Request for additional information - Proposed staged subdivision

DA 8/2016/557/1 - Wine Country Drive, Rothbury

Proposed Plan of Subdivision Lot 11 DP 1187663 & Lot 2 - 4 DP 869651 Wine Country Drive, Rothbury Sheet 5 of 5

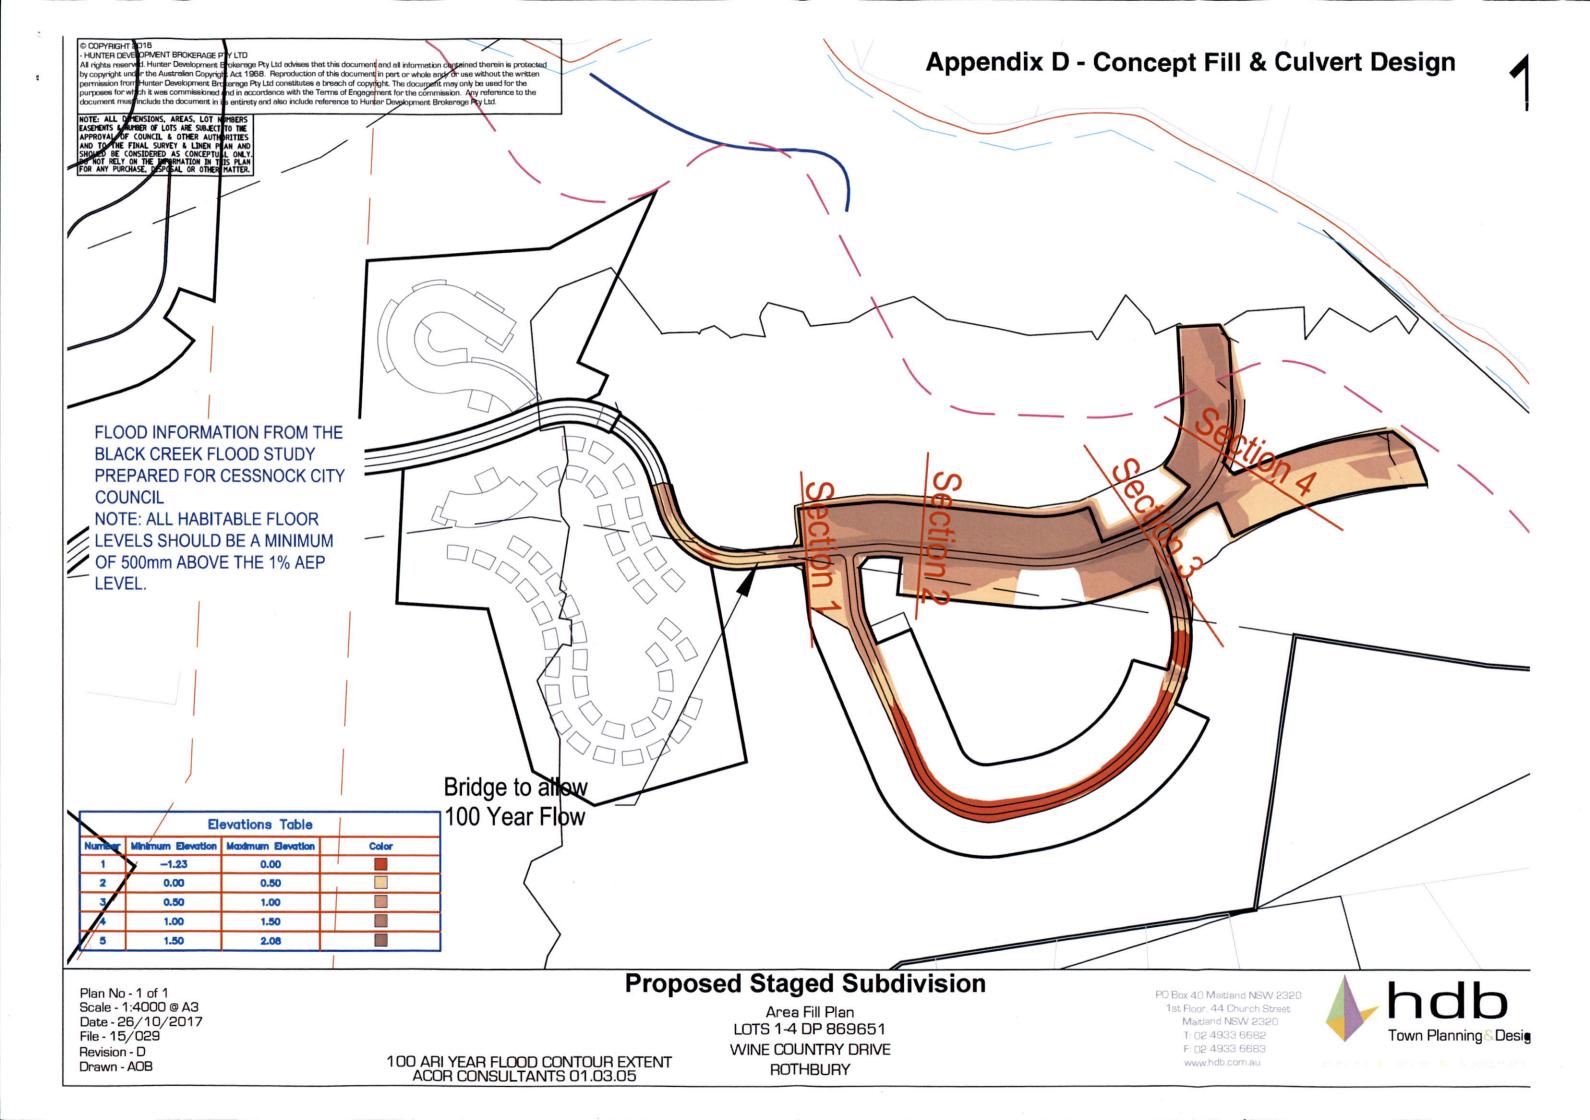
- i. Revised Concept Master Plan, dated 24/10/2018 reflecting the amended subdivision layout;
- ii. Revised Plan of Subdivision, dated 24/10/2018 reflecting the proposed amendments to the super lots; and
- iii. Revised subdivision plan with overlaid Flood Category.

Section 3

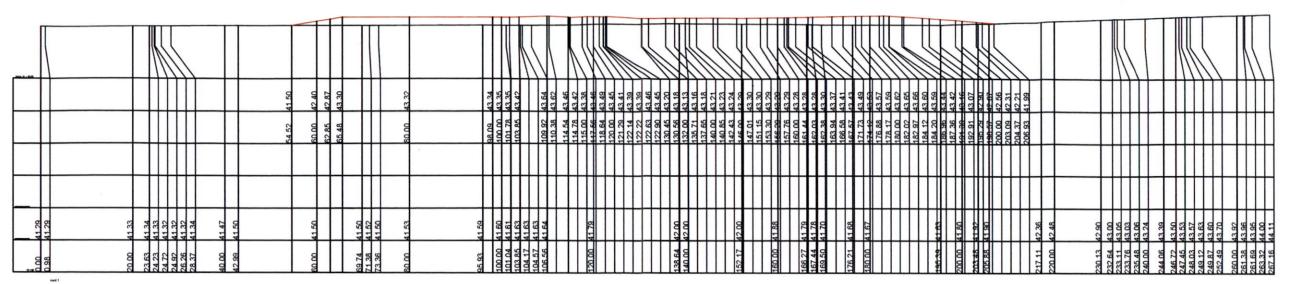
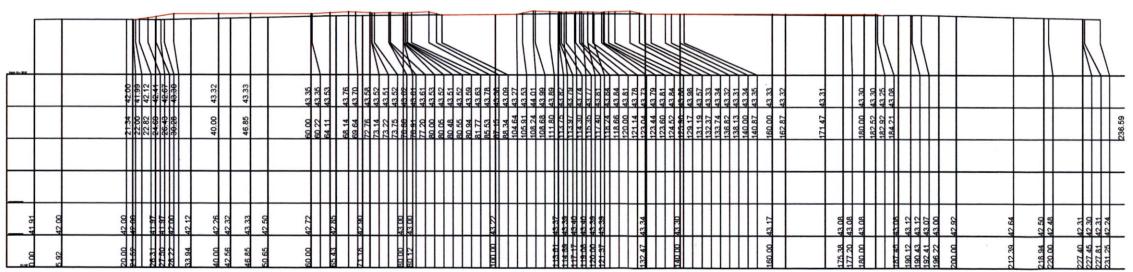
As advised in this letter, flood free access and exit to *Lot 305* can be achieved by a minor land fill along with the installation of a suitably designed box culvert to raise the road above the 1% AEP without affecting the flood flows. Refer to **Appendix D** for concept plans showing the proposed fill areas and culvert location.

The extrapolated 1% AEP flood event for this section of land (Appendix E) shows a maximum flood water level at RL42.75. The natural surface at this point is 42m AHD which gives a maximum depth of water at 0.75m in the 1% AEP. As shown in the attached road cross section 3 (Appendix D) the proposed fill will raise the surface level of that part of the road up to RL43.64, which is approximately 900mm above the projected maximum water levels for 1% AEP flood event. This road therefore, satisfies the NSW floodplain development manual requirements for a safe evacuation route.
